Ann Arbor VA
Parking Deck Expansion

Proposed handrail at
stone cap

Level B Along A Line
26 posts total

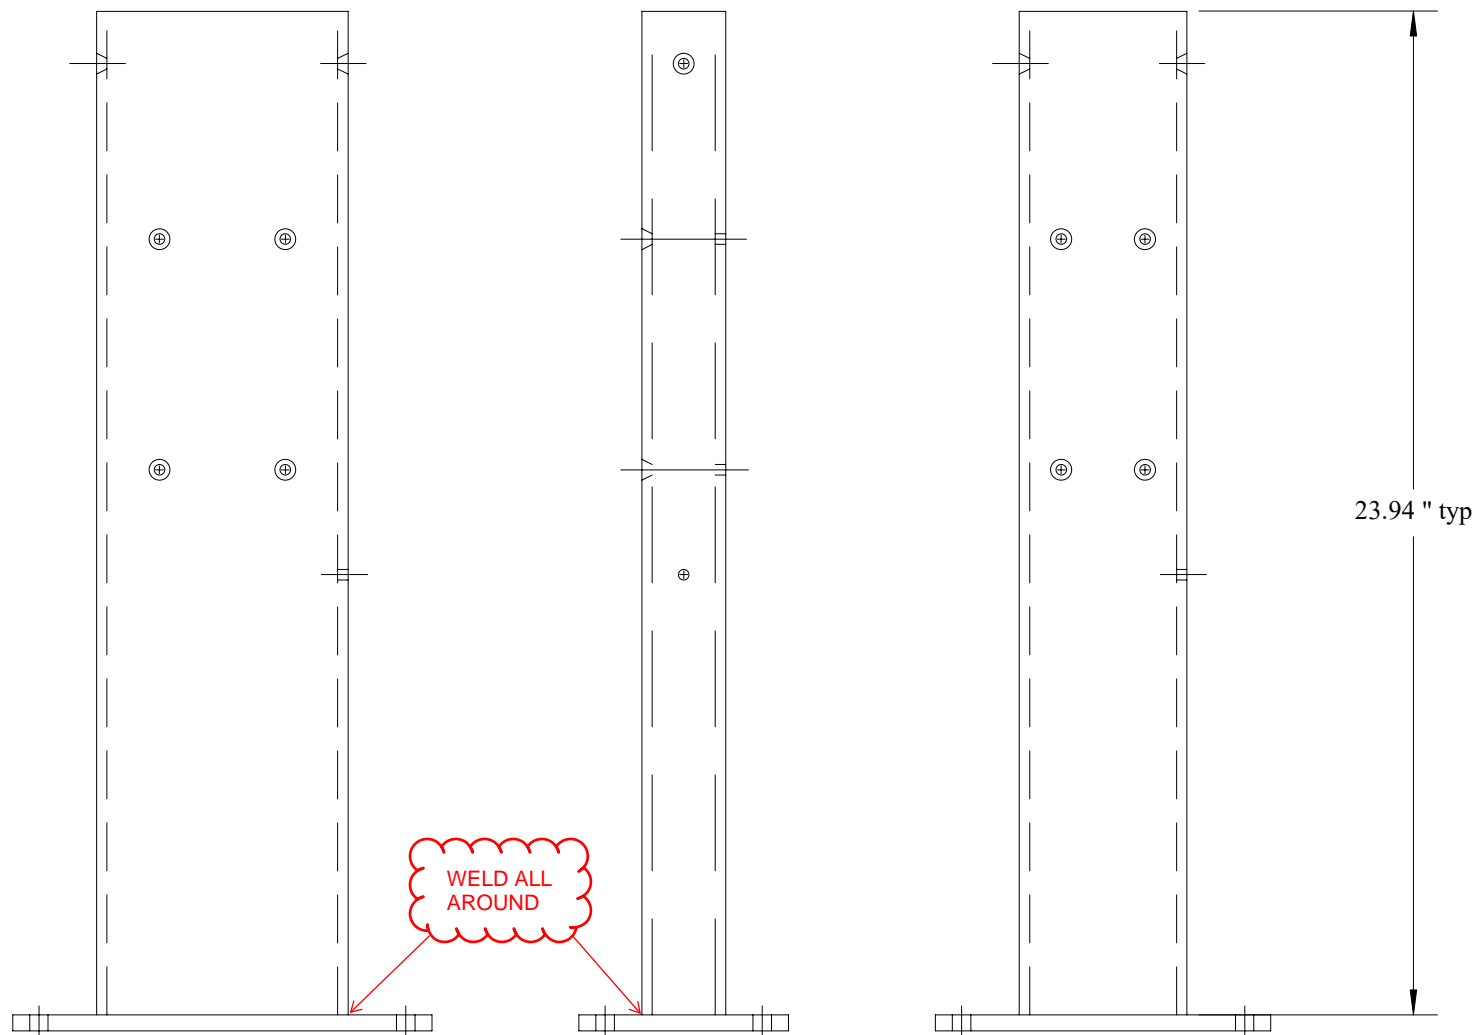
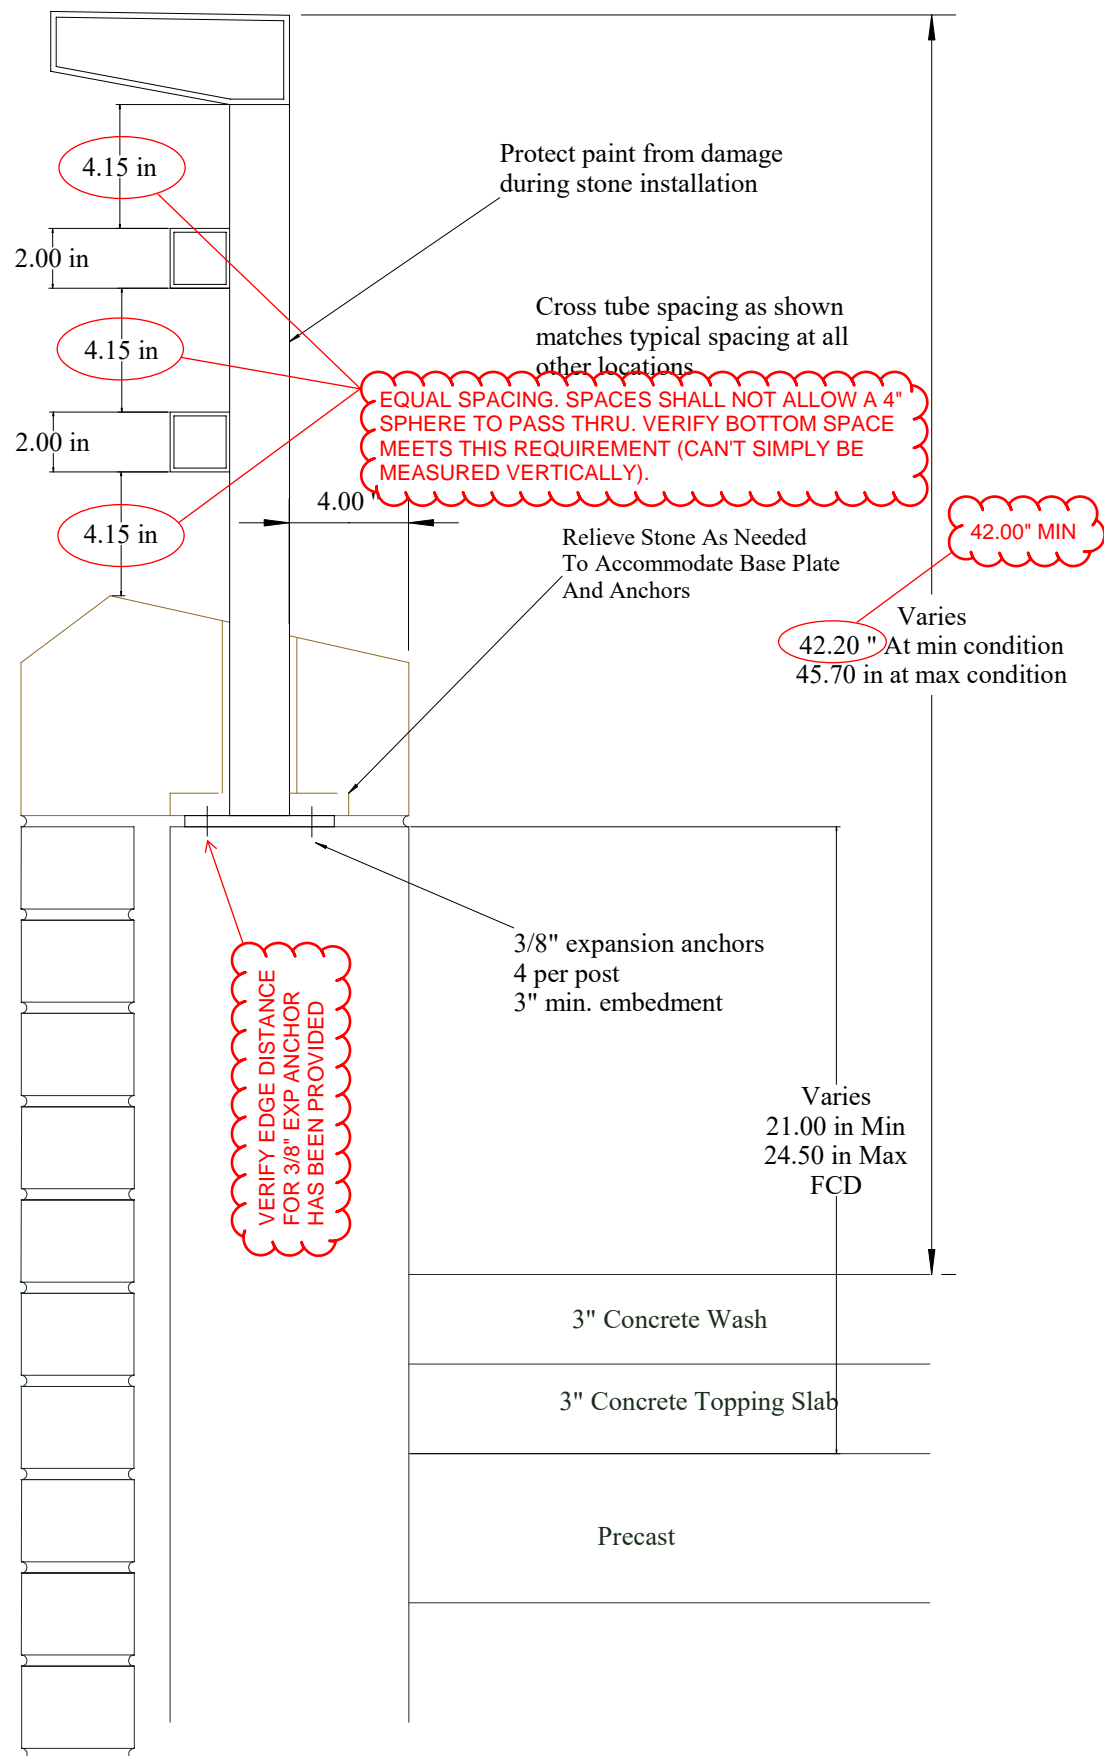
POST SPACING TO MATCH
LEVELS ABOVE

DESIGN TO MEET LOADING
REQUIREMENTS - SEE SPECS
